DFCM Addendum #3

Reference: Bastian Equestrian Arena
DFCM Project #25401770
U3P Event #CS25039-Stage II

ADDENDUM NO. 1
April 14, 2025

USU Bastian Equestrian Arena

A1 LEVEL 2 ENLARGED ANNOUNCERS BOOTH
1/4" = 1'-0"

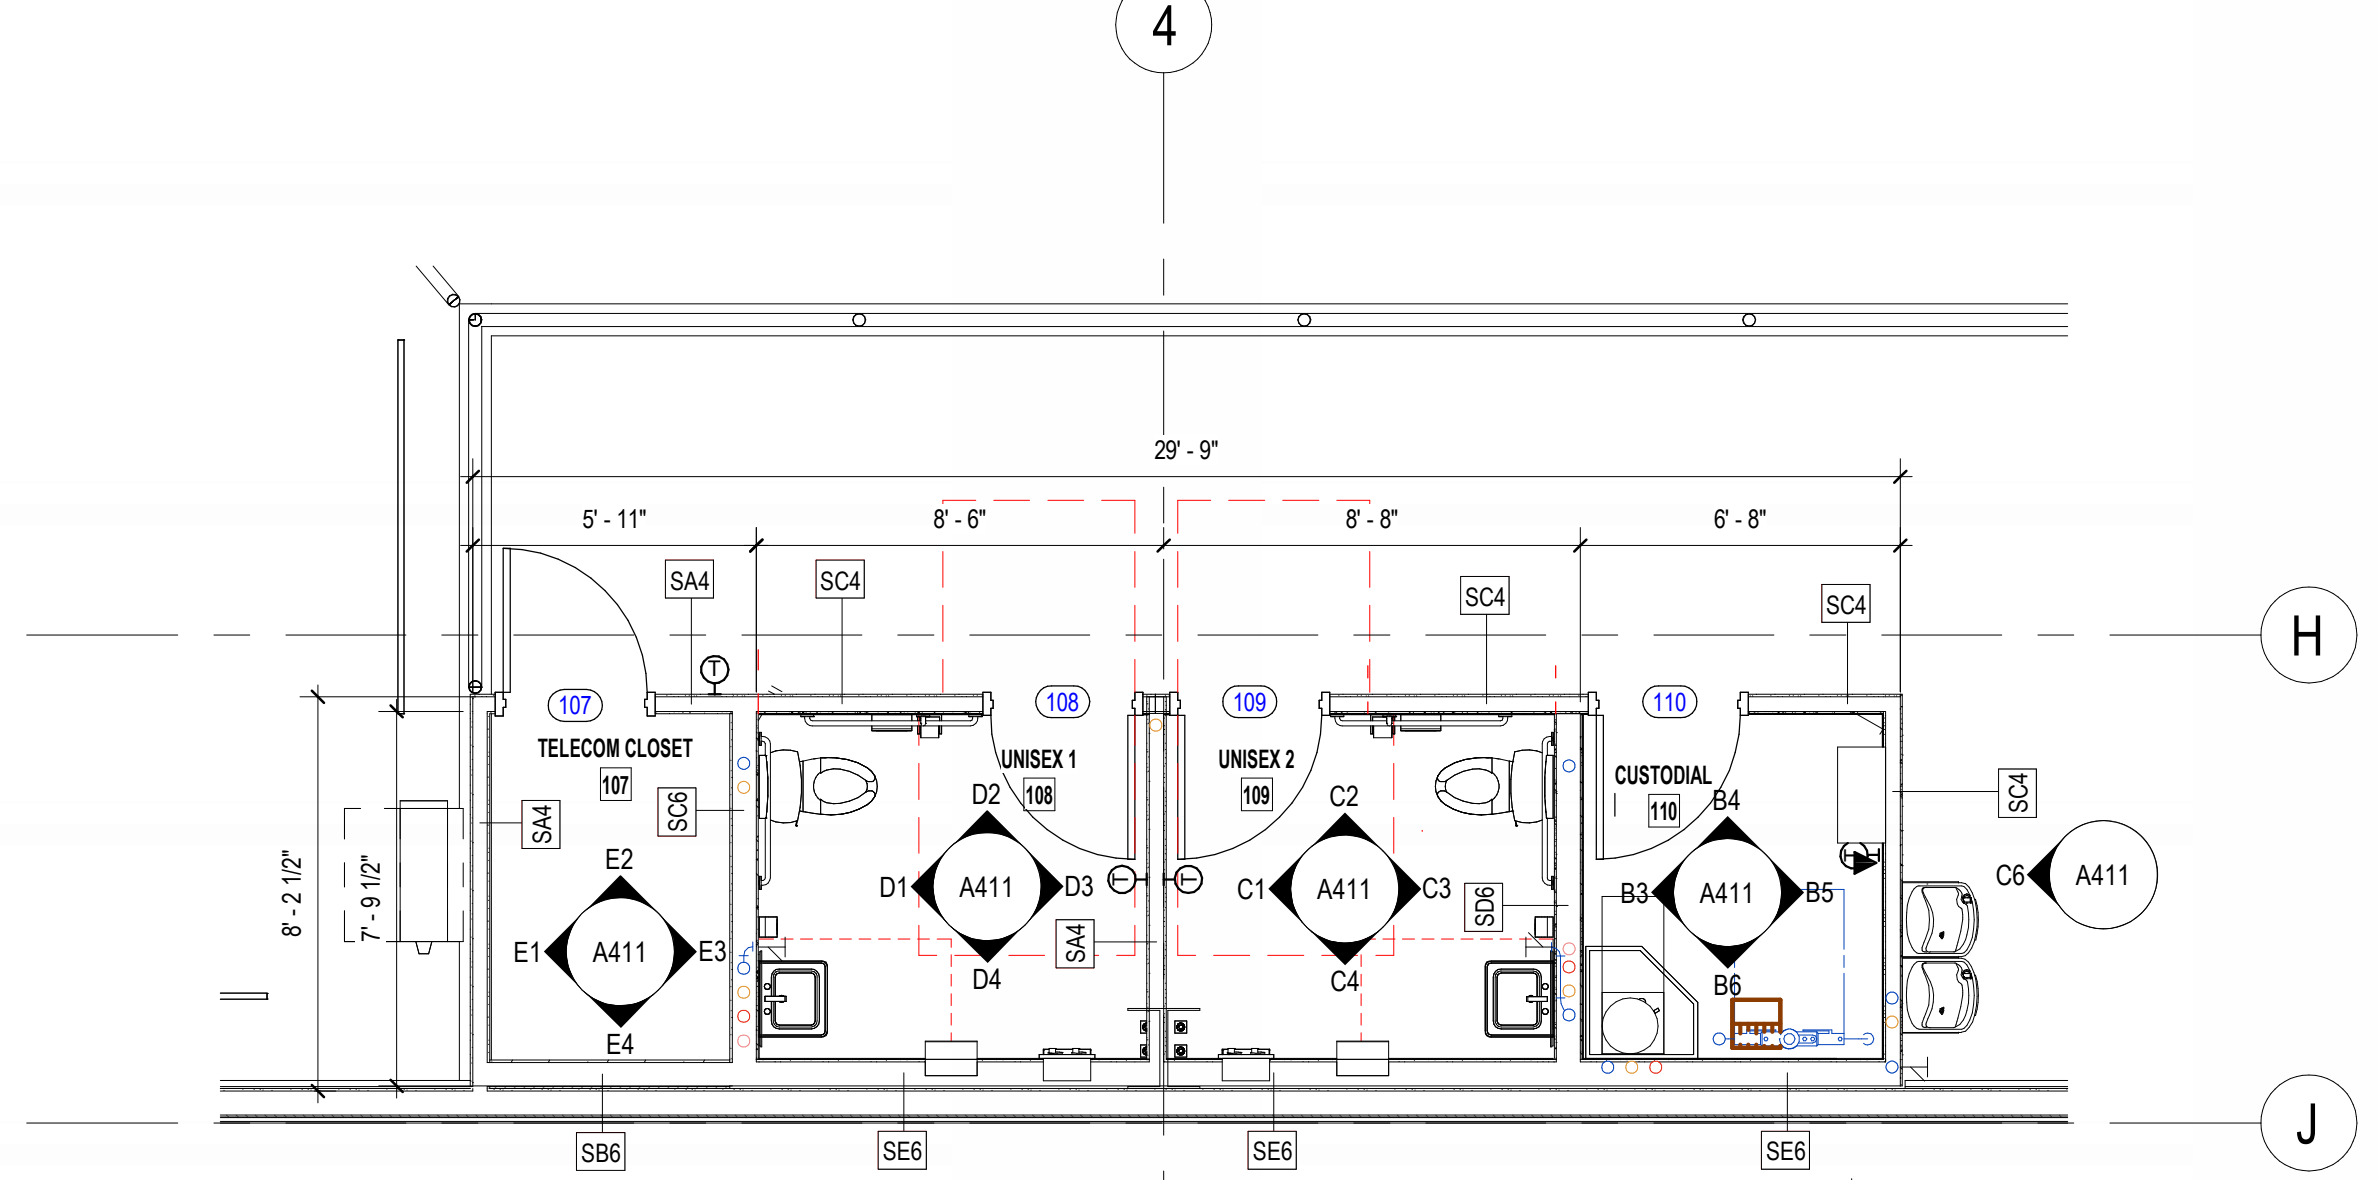
Question 008 - A411 – Note: USU typically provides a sanitary napkin vending station. If it is provided, where will it be mounted in the toilet rooms?

Question 024 - Tie Rail – keynote 05.09 indicates detail on elevation. Please provide detail as no detail is shown on elevation.

Response: A sanitary napkin vending station has been added to the restroom elevations and the accessory schedule. See sheets A411 and A601.

Response: A new detail has been added to the drawings for this tie rail ON C4/A511 and called out on the interior elevations for the arena on sheet A213. See clouded drawings.

GENERAL
CONST.
DETAILS

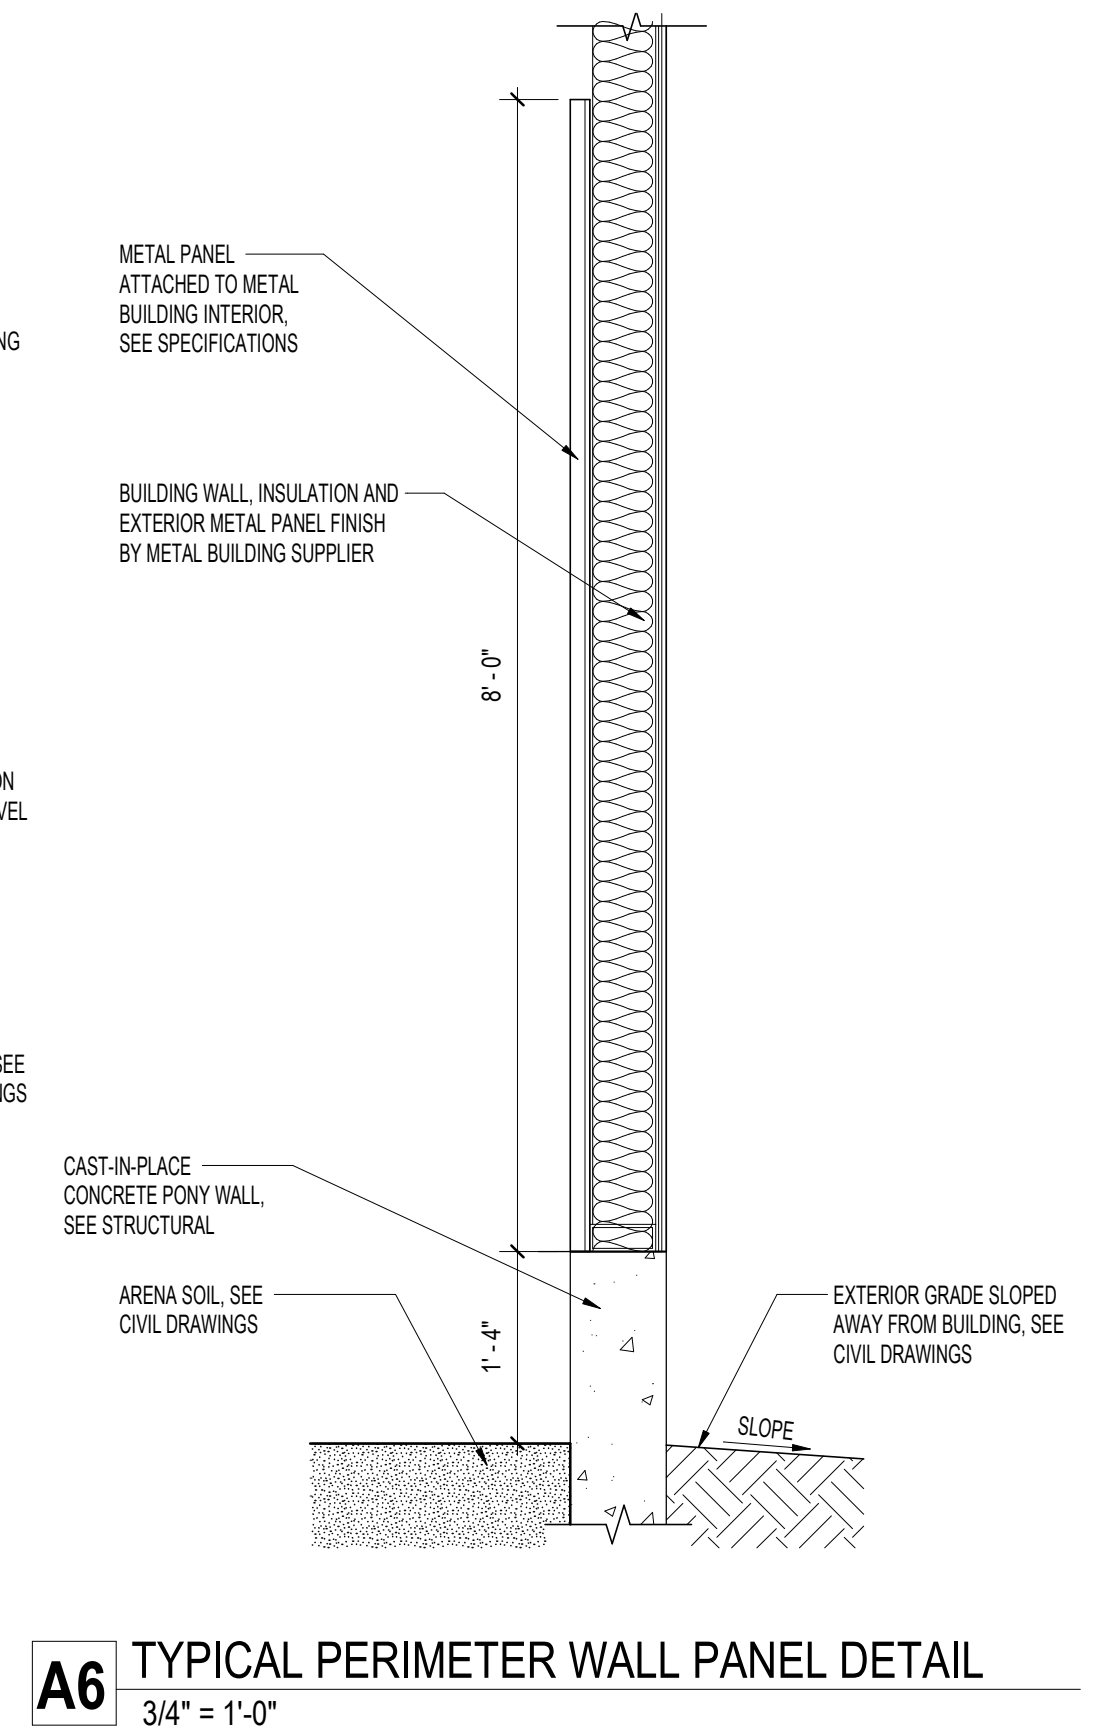
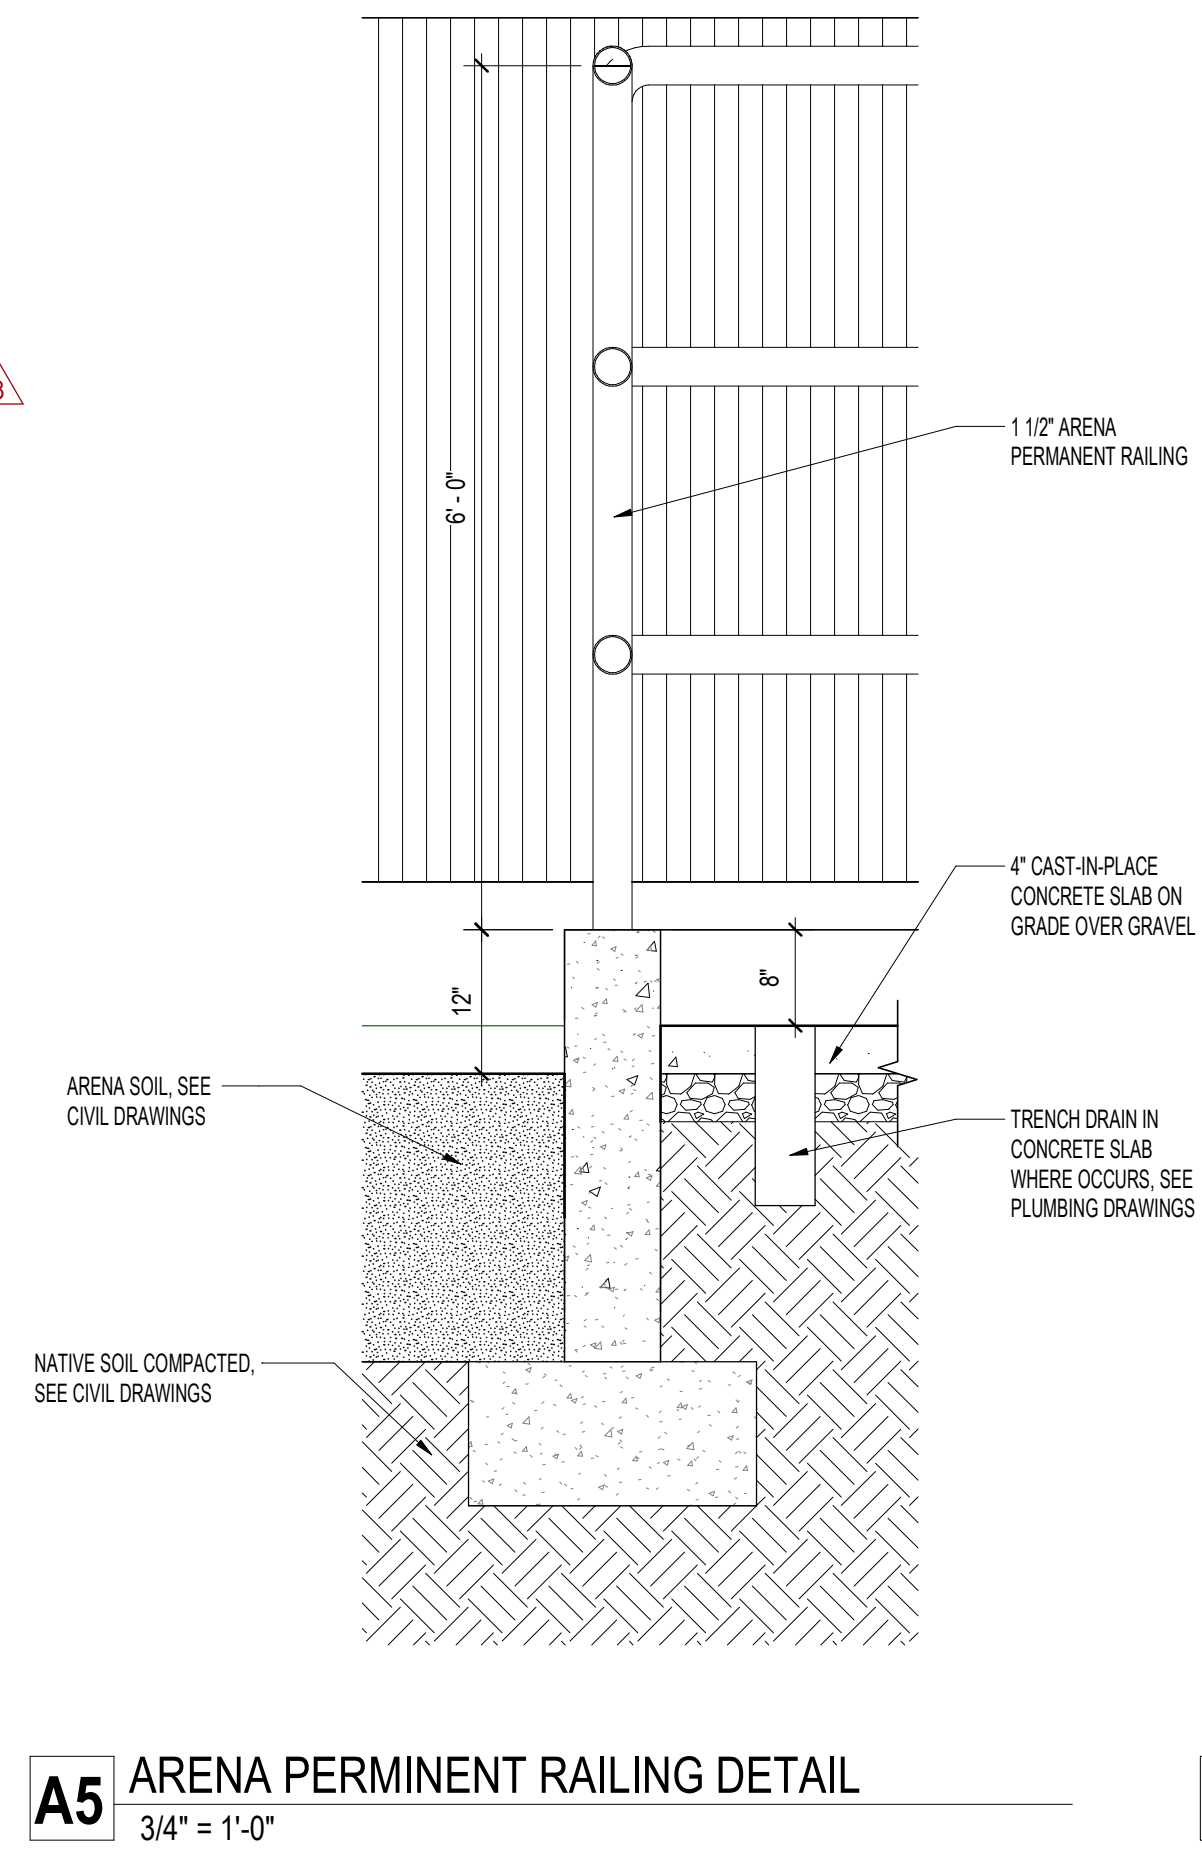
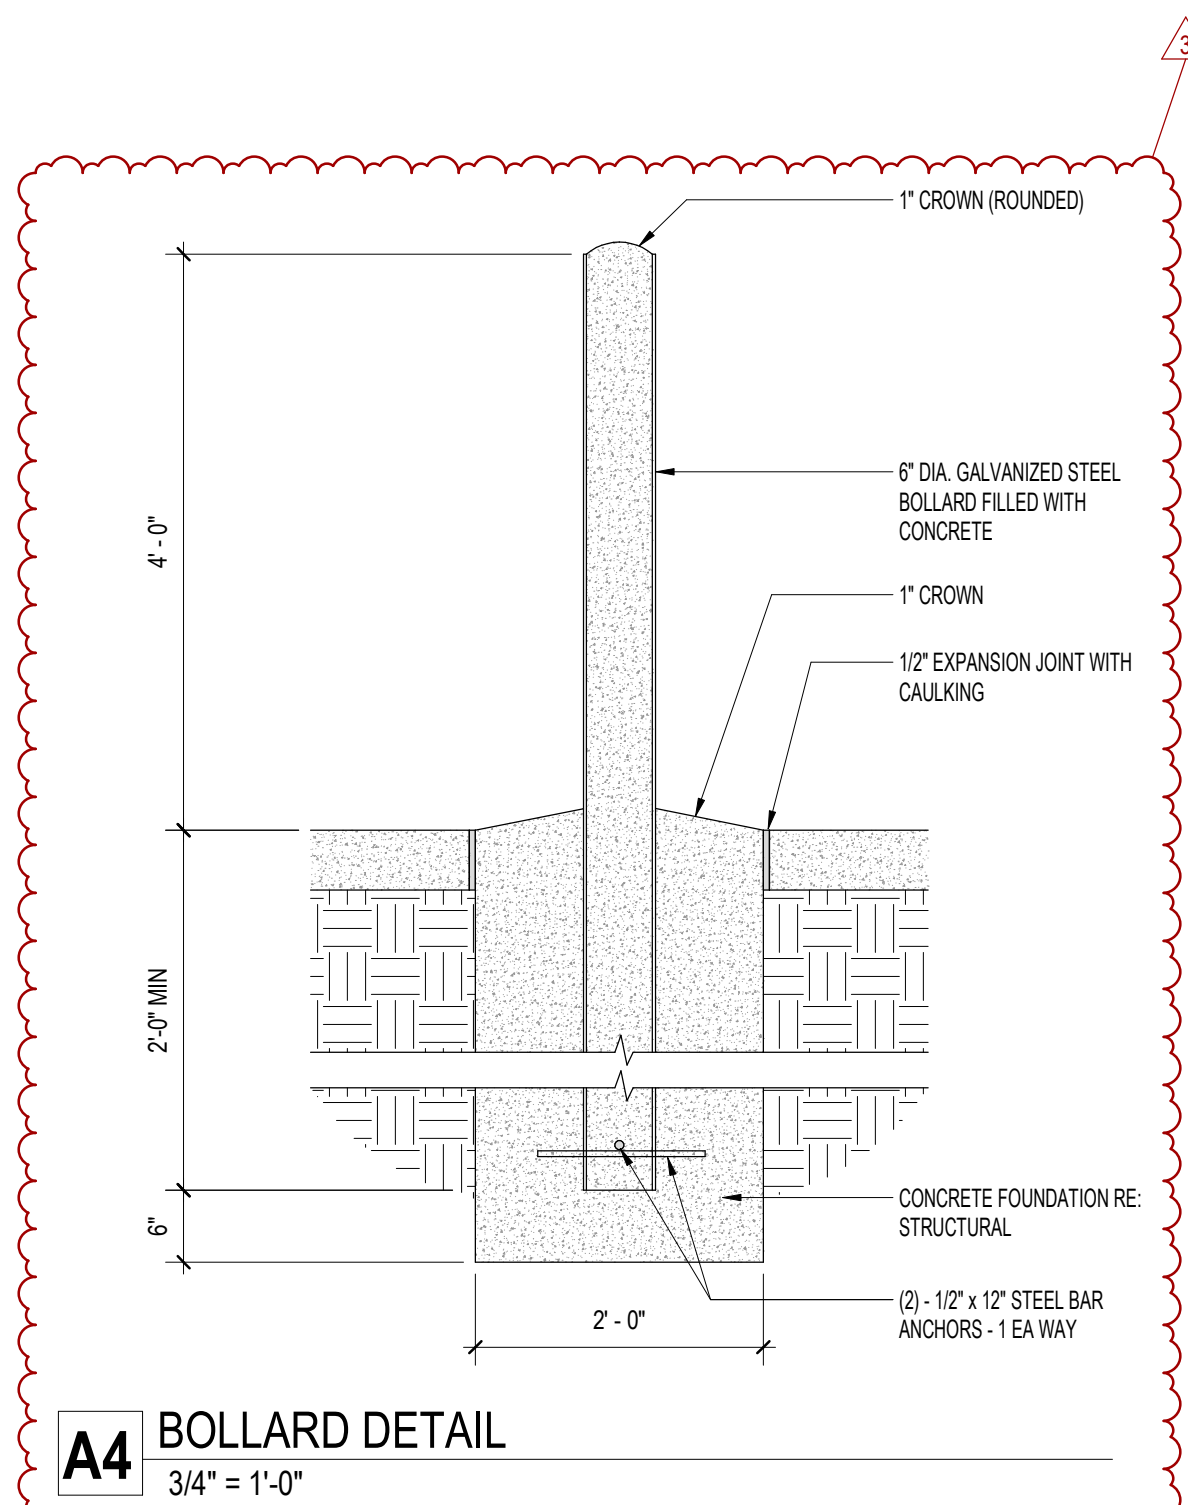
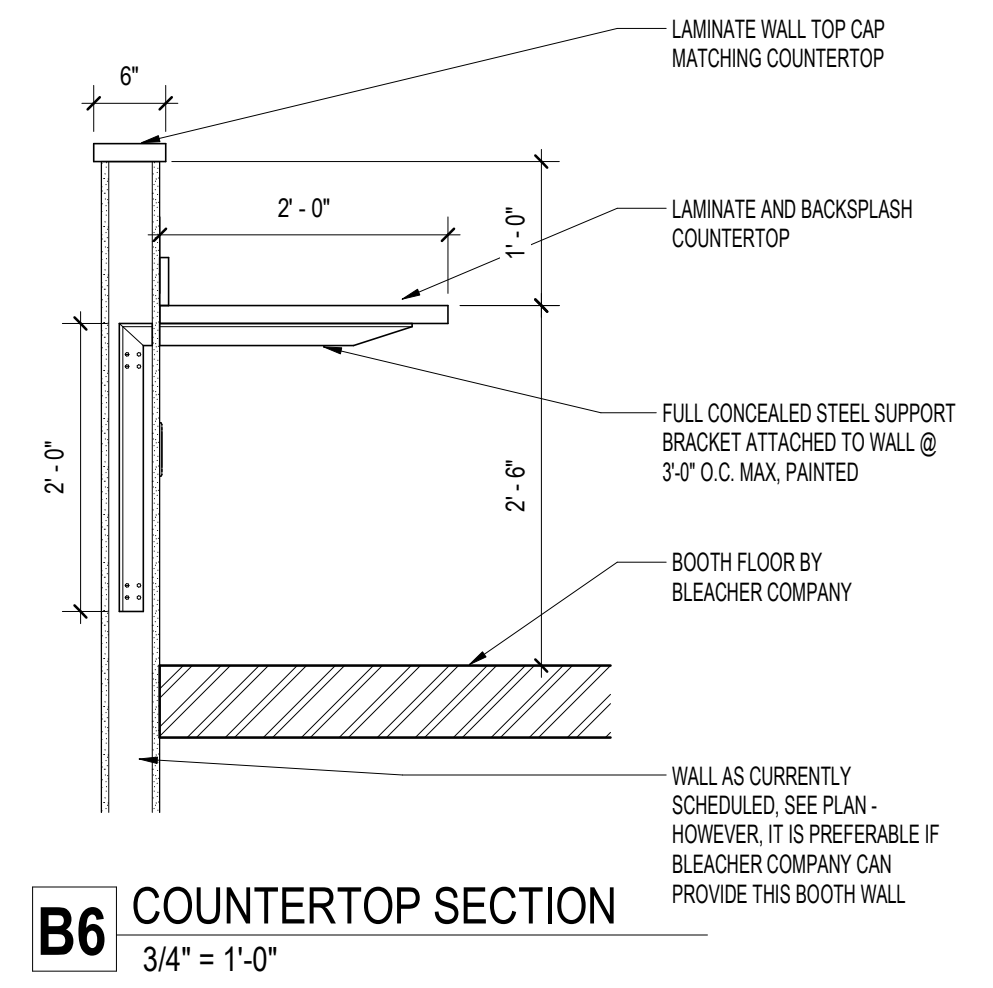
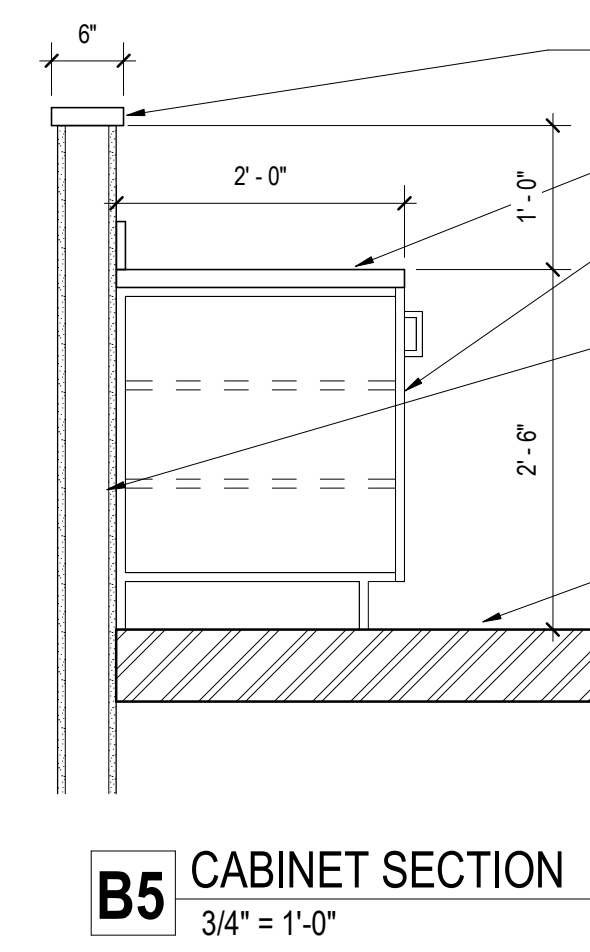
Question 003 - C201 – keynote 7: coordinate location of frost-free hydrants relative to adjacent bollards. Provide bollard detail

Question 023 - 6" curb around railing – Wall type CU8 (concrete wall) shows only at booth, the intent appears to be all around for arena railing – please confirm limits of concrete wall?

Response: Provide frost-free hydrants per locations and number shown on C201. Bollard locations and detail have been updated and added to architectural plan A101 and A511.

Response: The CU8 wall type is shown only on the 3 sides of the audience area slab, not at the announcer's booth. The permanently installed arena railing should be installed in the CU8 wall type per detail A5/A511. Any other arena railings shown are all moveable railings depending on the event happening in the arena.
